ADDENDUM NO. 4

February 10, 2023

SOLON ROBINSON ELEMENTARY SCHOOL ADDITIONS, RENOVATIONS, AND RELATED WORK Crown Point, IN 46307

G-201

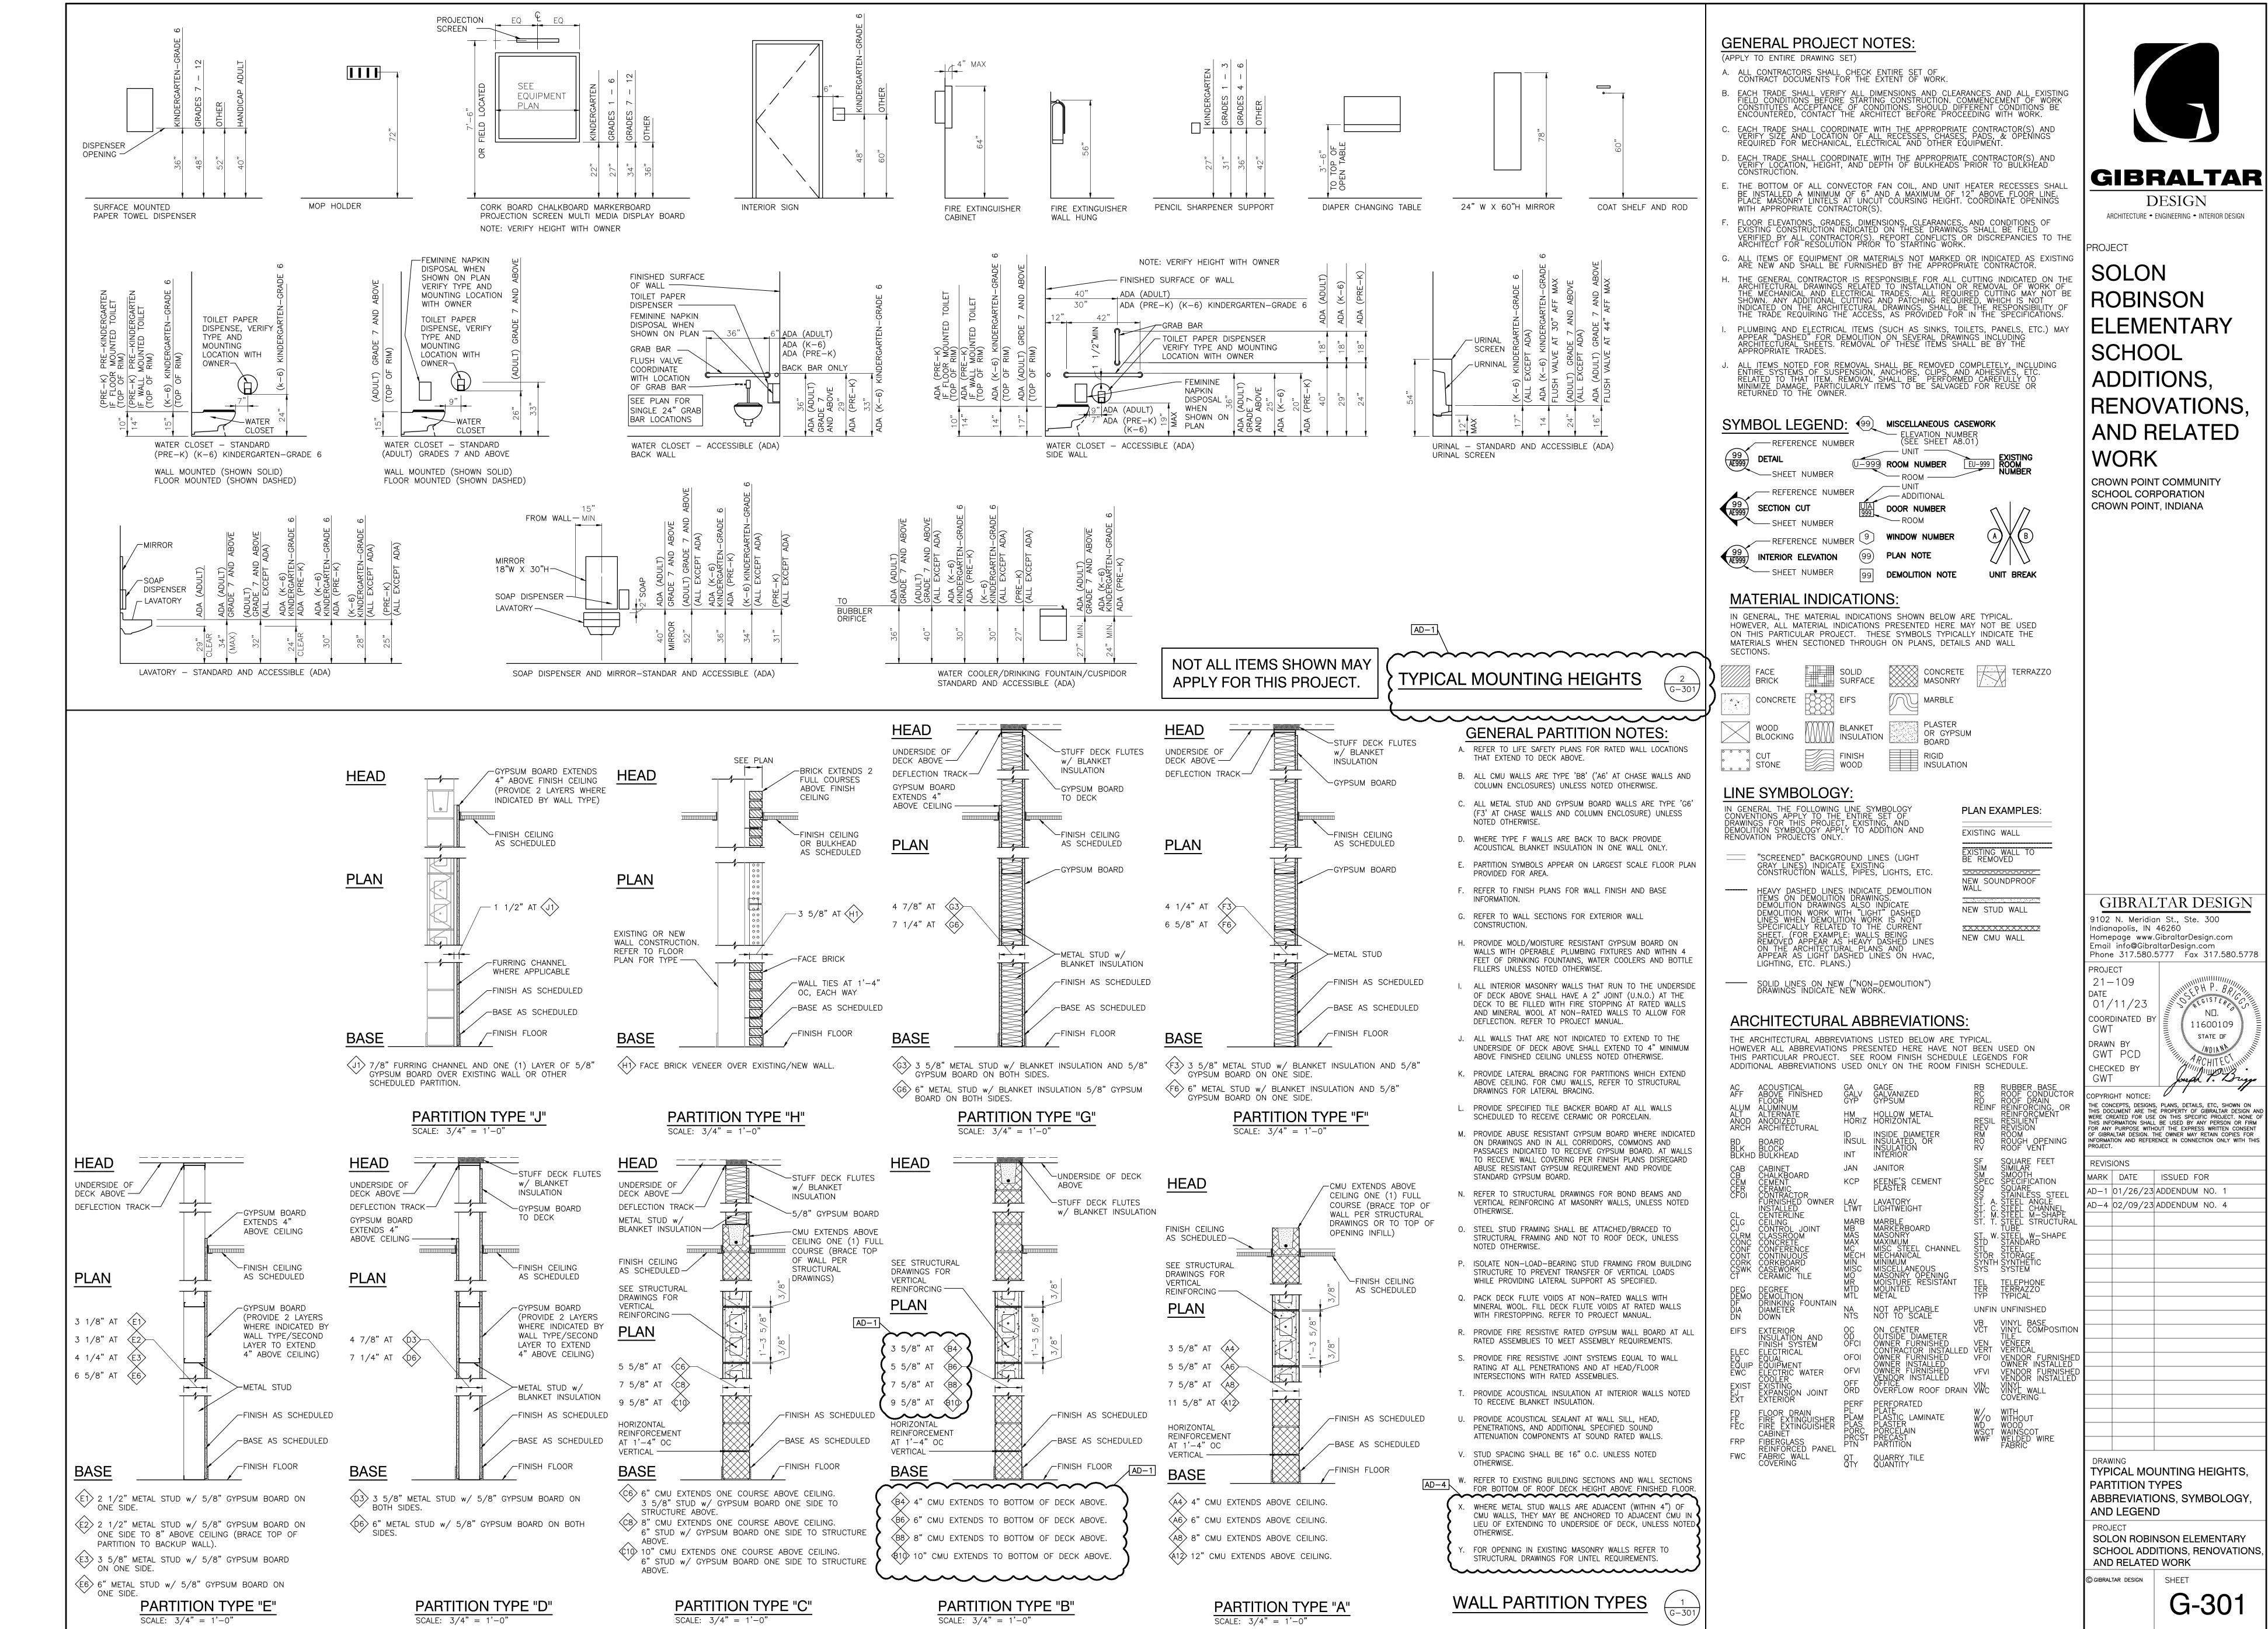
1. Sheet G-201

A. First Floor Life Safety Plan: Delete entrance numbers in Courtyard.

AD101

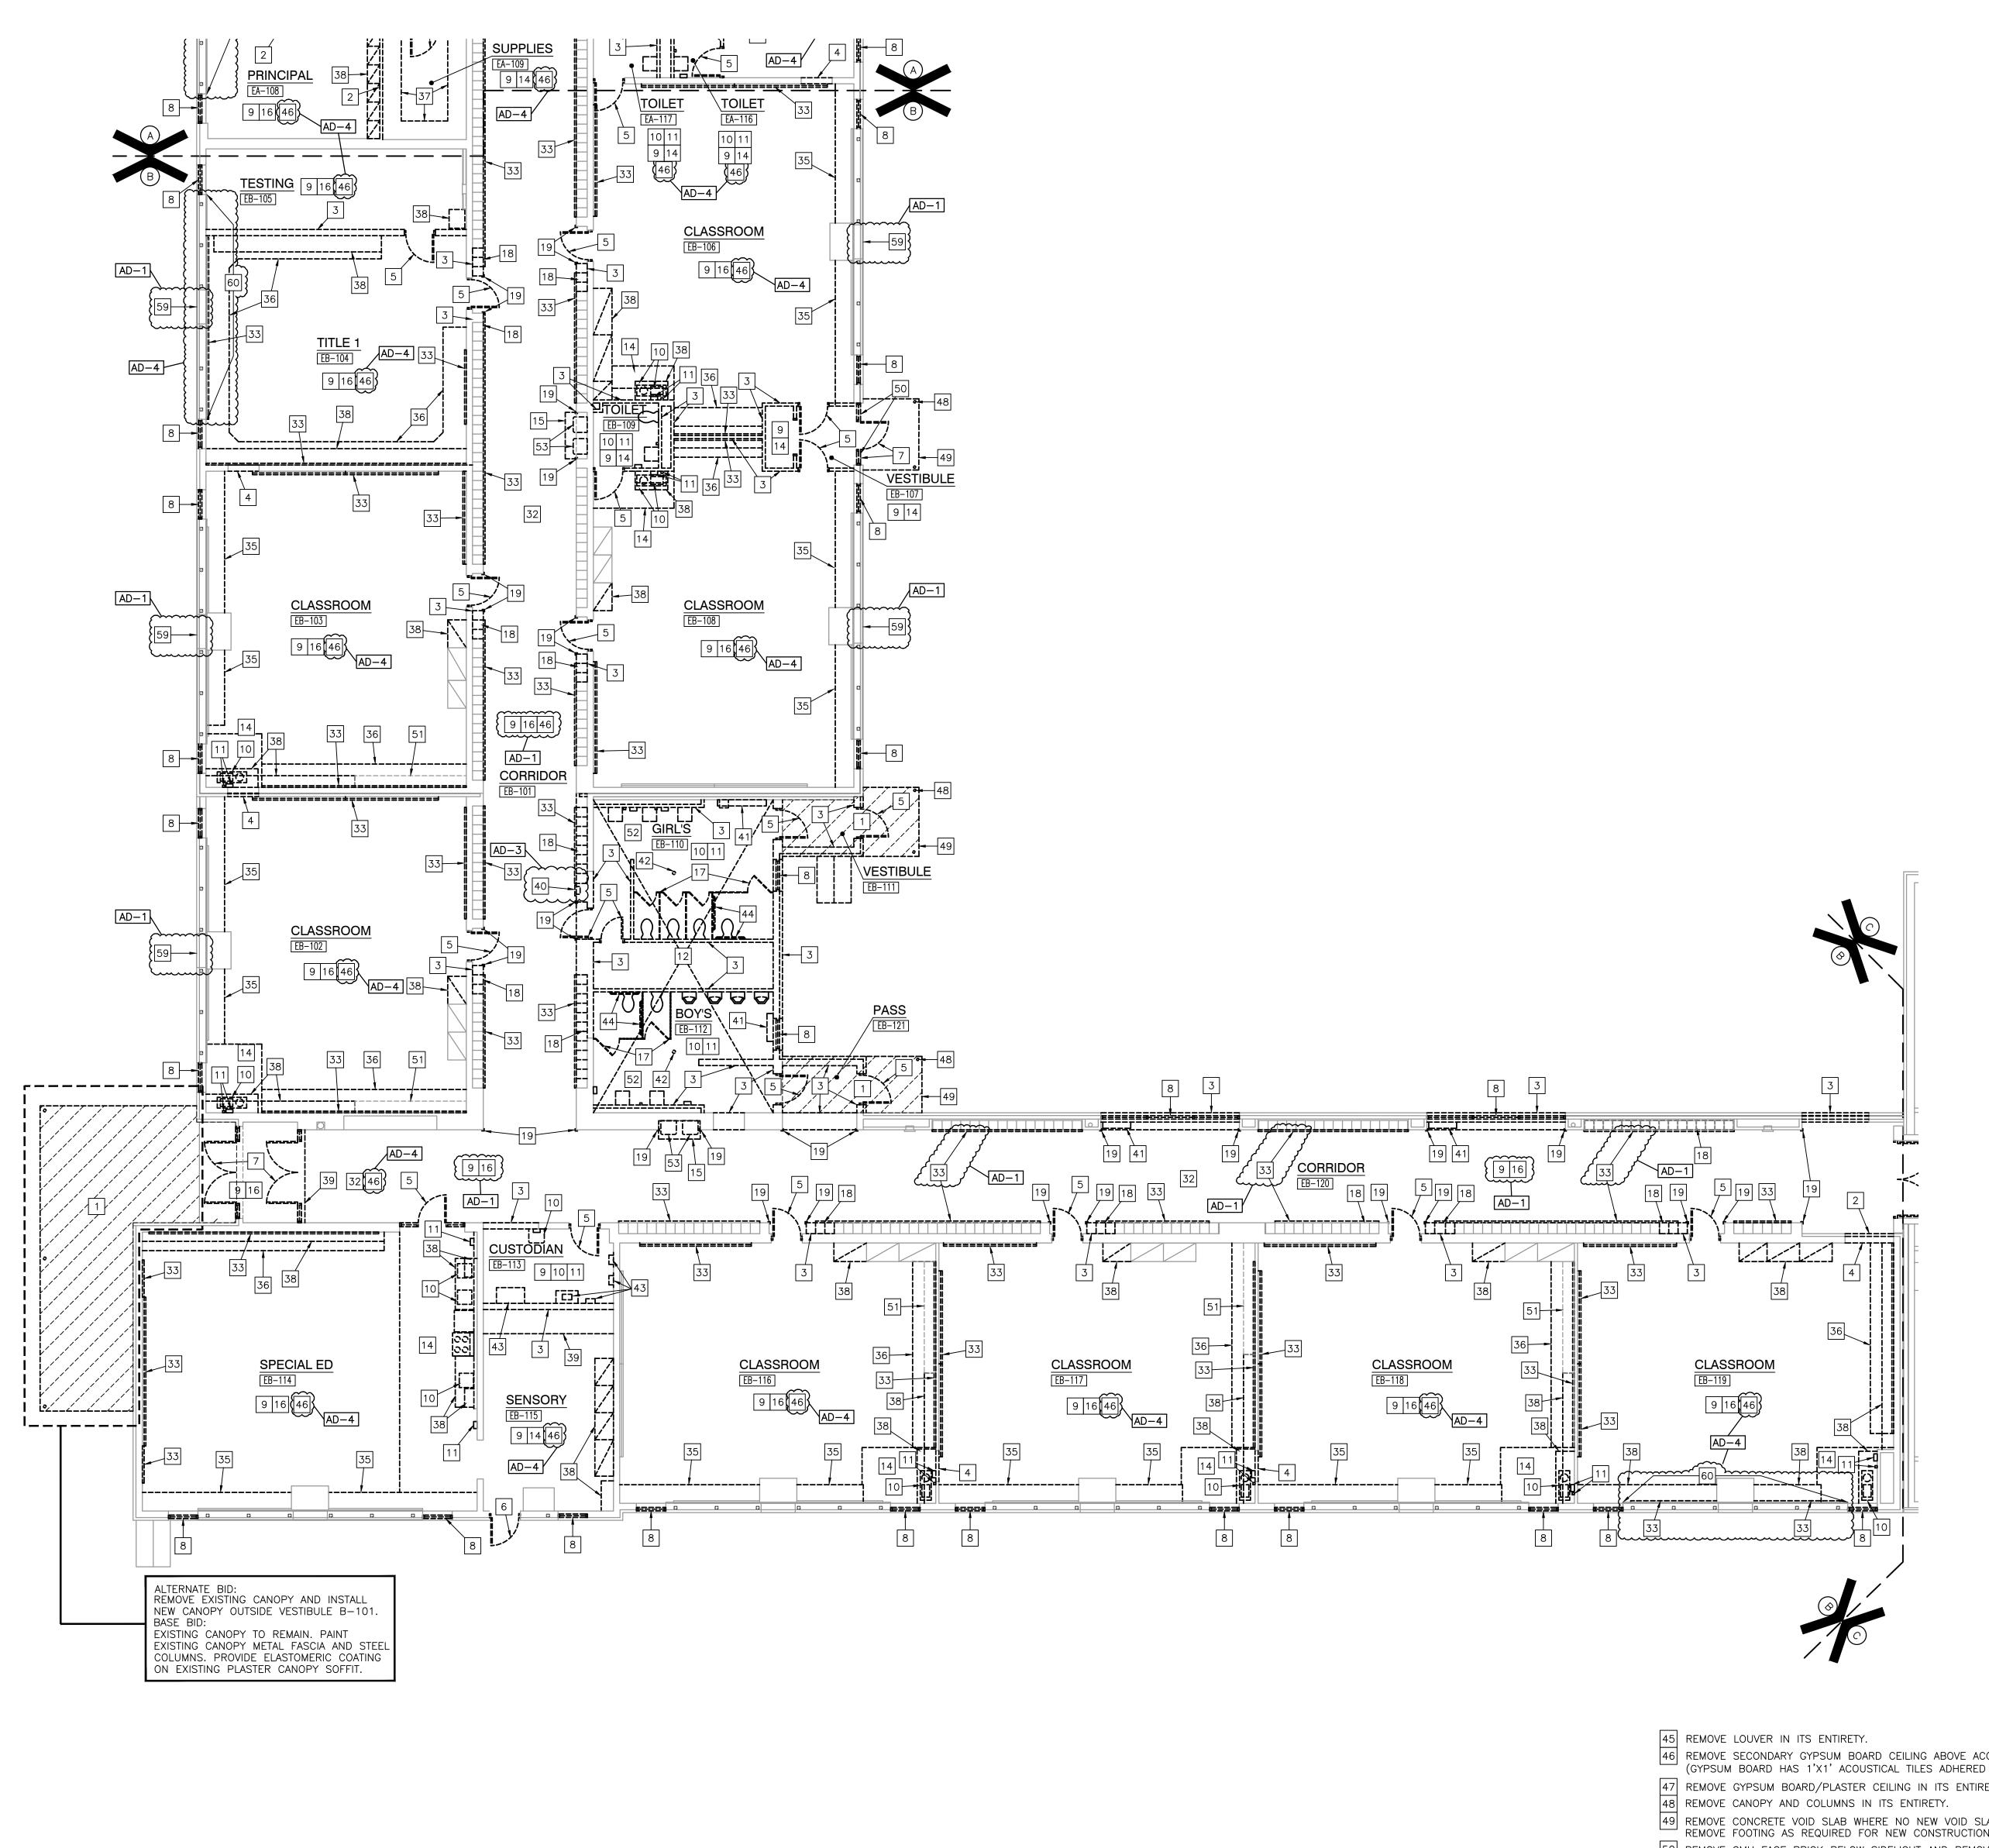
- A. Unit "A" Architectural First Floor Demolition Plan: Add Plan Note "46" to various rooms regarding removal of secondary ceiling. In Corridor EA-124 add Plan Note "3" regarding removal of masonry wall. In rooms EA-104, EA-106, EA-107, EA-108, EA-113, EA-115, and EA-118 add plan note regarding removal of gypsum board and metal furring.
- B. Unit "B" Architectural First Floor Demolition Plan: Add Plan Note "46" to various rooms regarding removal of secondary ceiling. In room EB-119 add note regarding removal of gypsum board and metal furring.
- C. Unit "C" & "D" Architectural First Floor Demolition Plan: Change Note "28" to read: "28. Remove basketball goal and support structure in its entirety."
- D. Unit "E" Architectural First Floor Demolition Plan: Add Plan Note "46" to various rooms regarding removal of secondary ceiling.
